NAPLES AIRPORT
RUNWAY 5/23 DRAINAGE IMPROVEMENTS, PHASE 3

ADDENDUM NUMBER TWO

April 20, 2022

TAXIWAY MARKING DETAILS

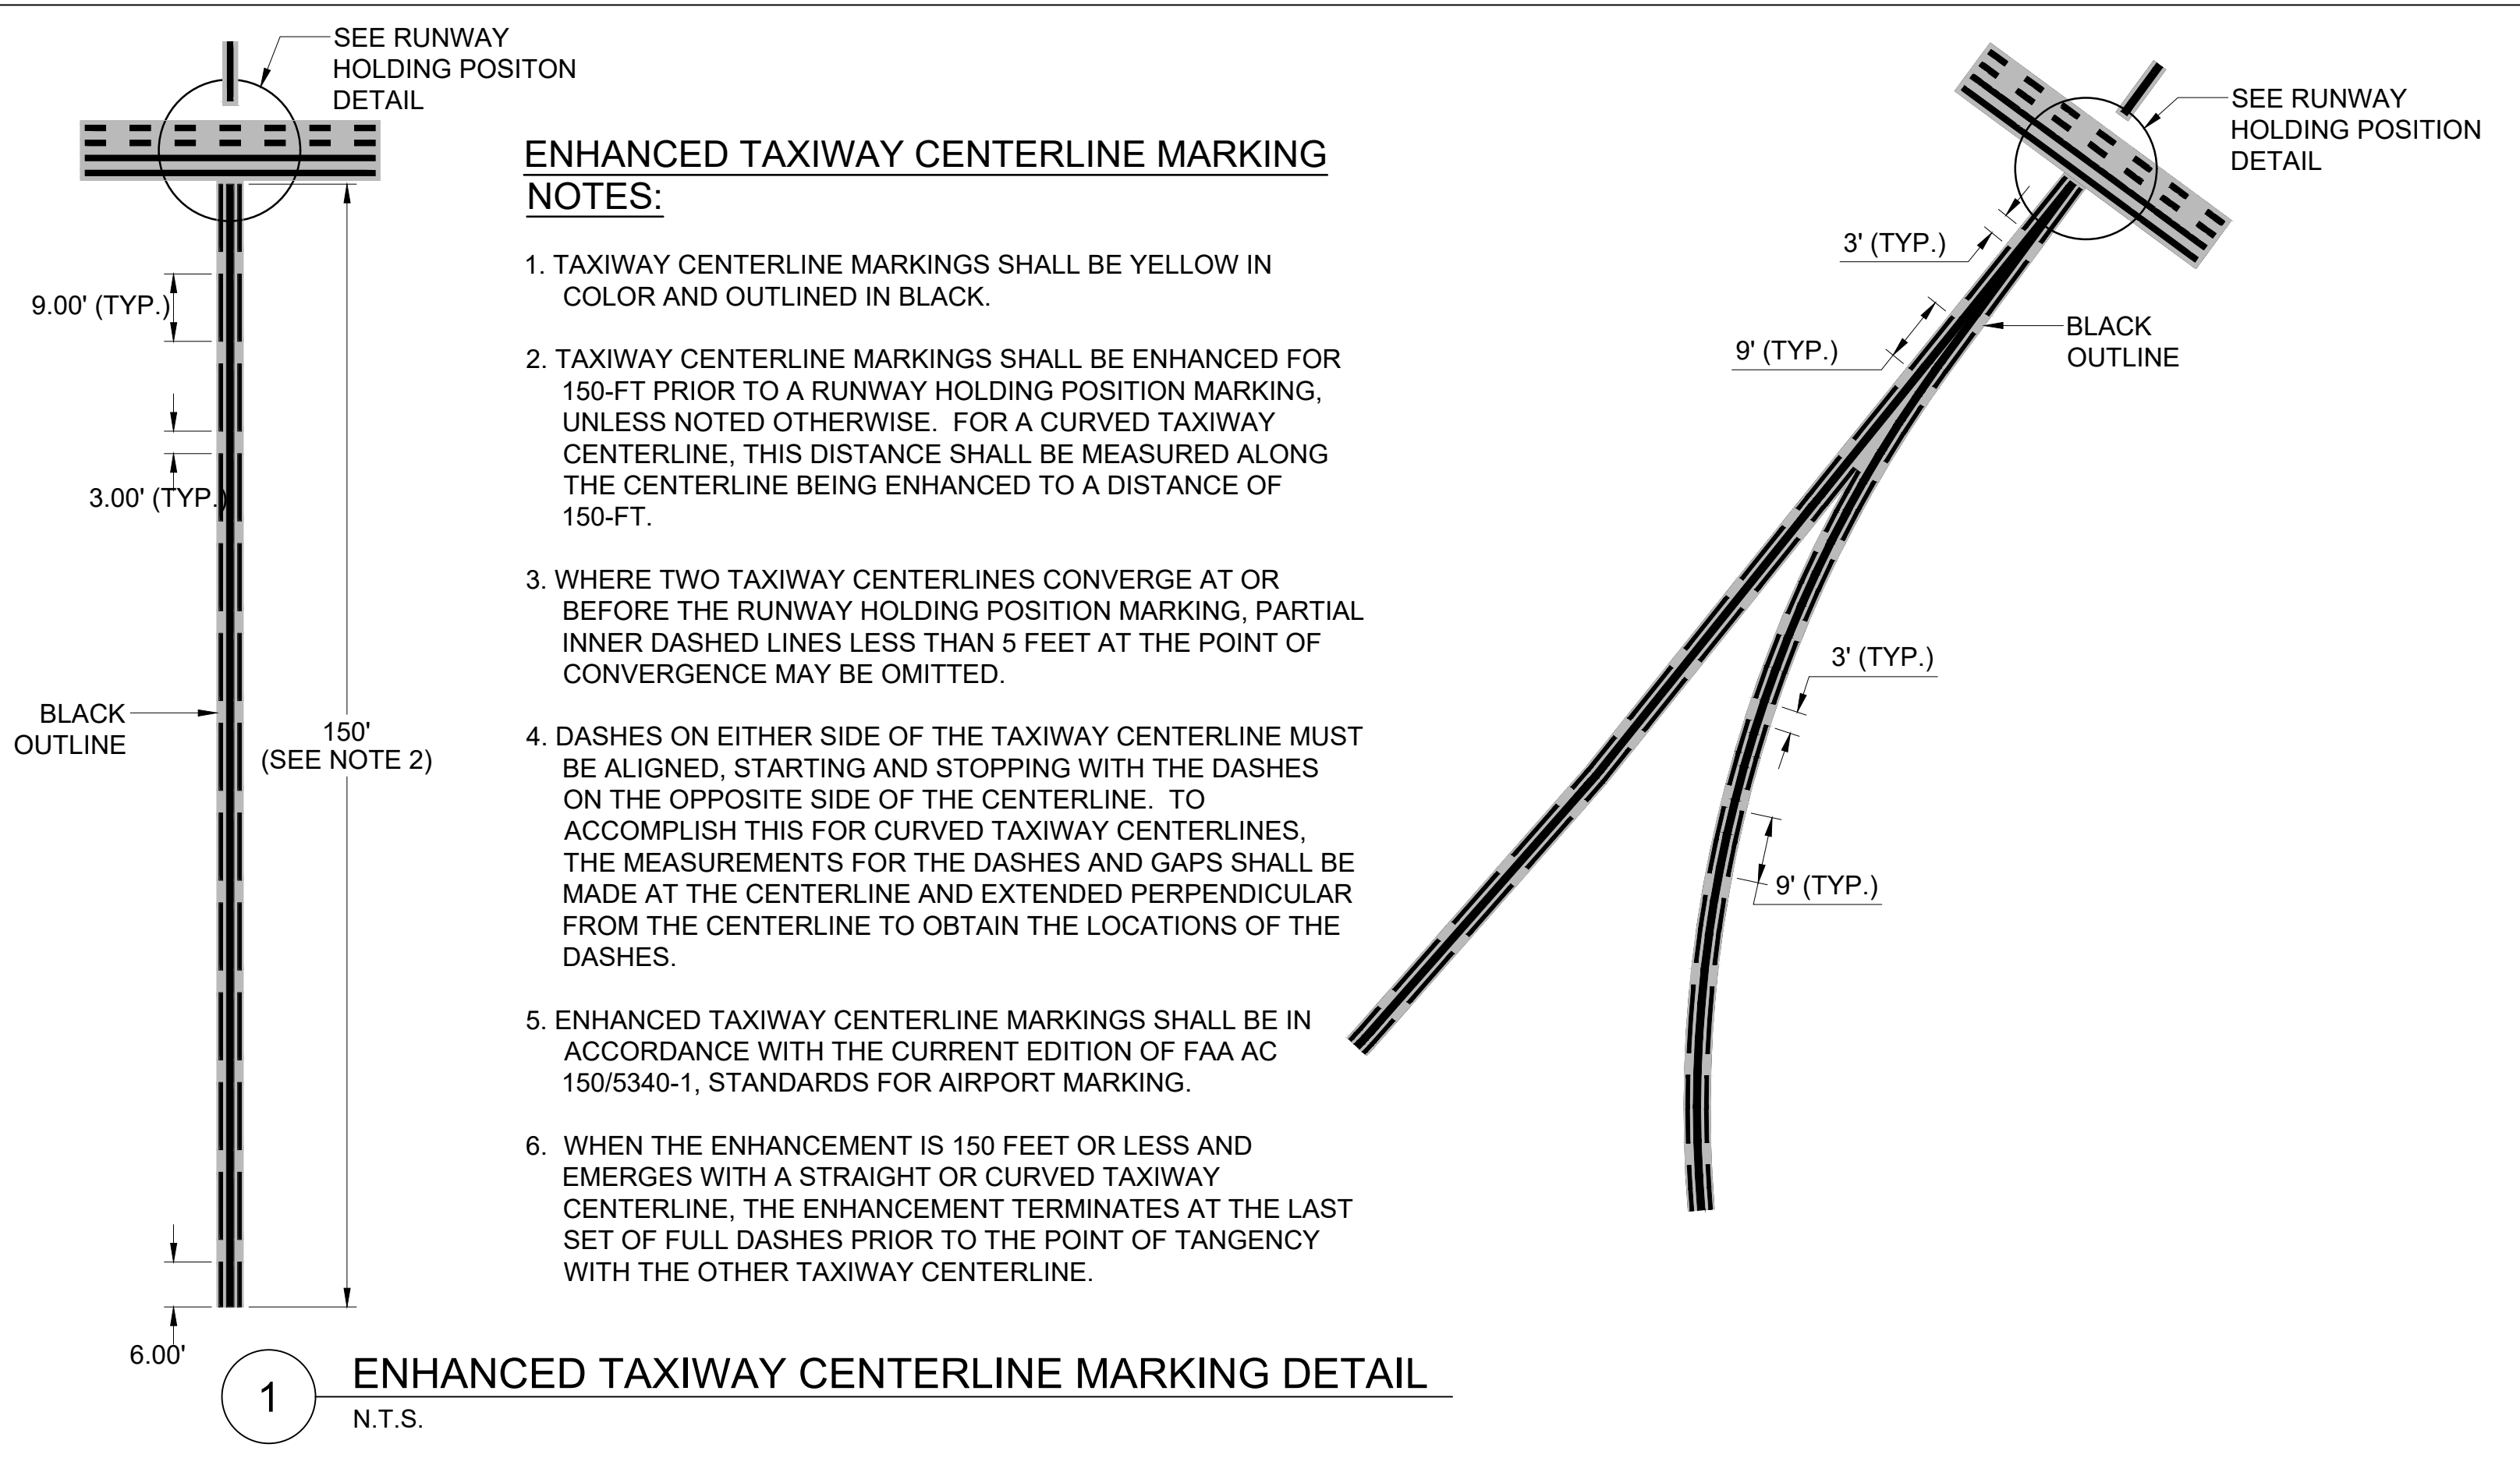
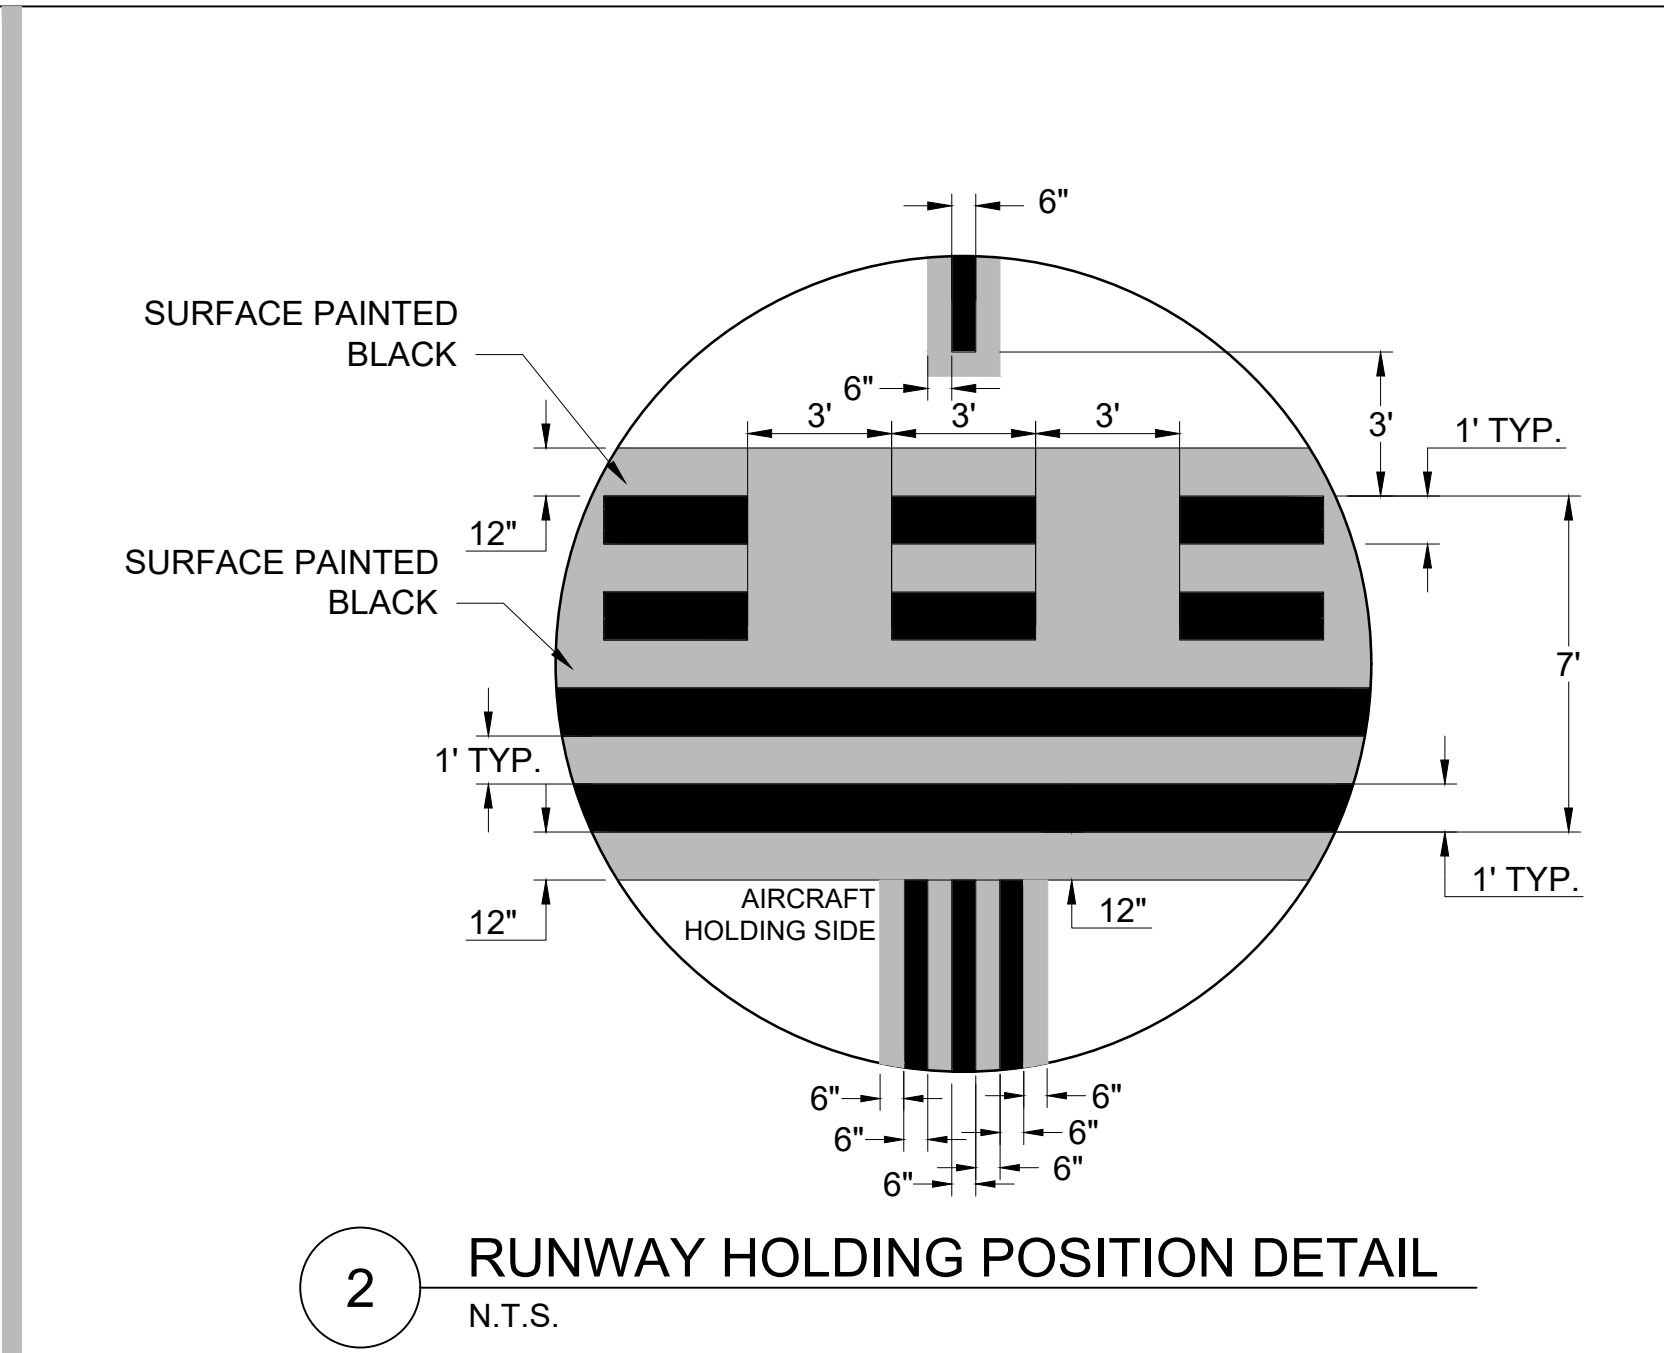
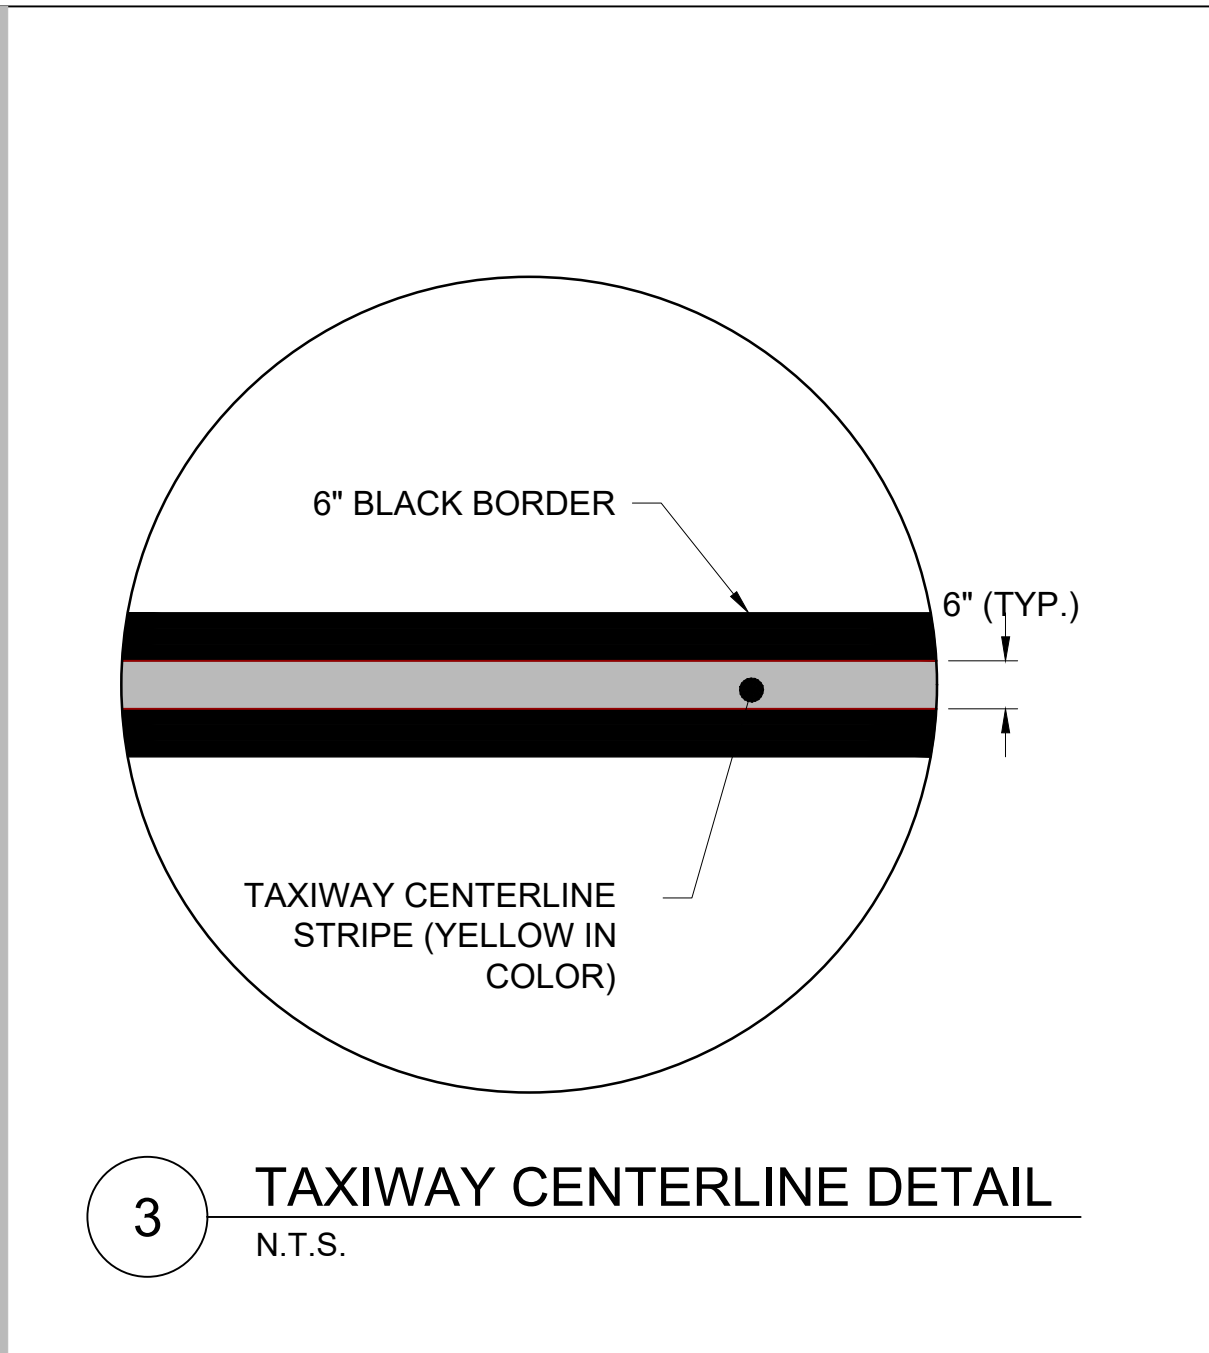
Question 3: Sheets C601 & C602 notes to 'Restore Asphalt Pavement and Repaint Taxiway Markings" at the proposed Taxiway pipe crossings. Details 3 & 4 on Sheet C404 appear to correlate with the notes on Sheets C601 & C602.

Answer: Sheet C603 Taxiway Marking Details has been added (see attached).
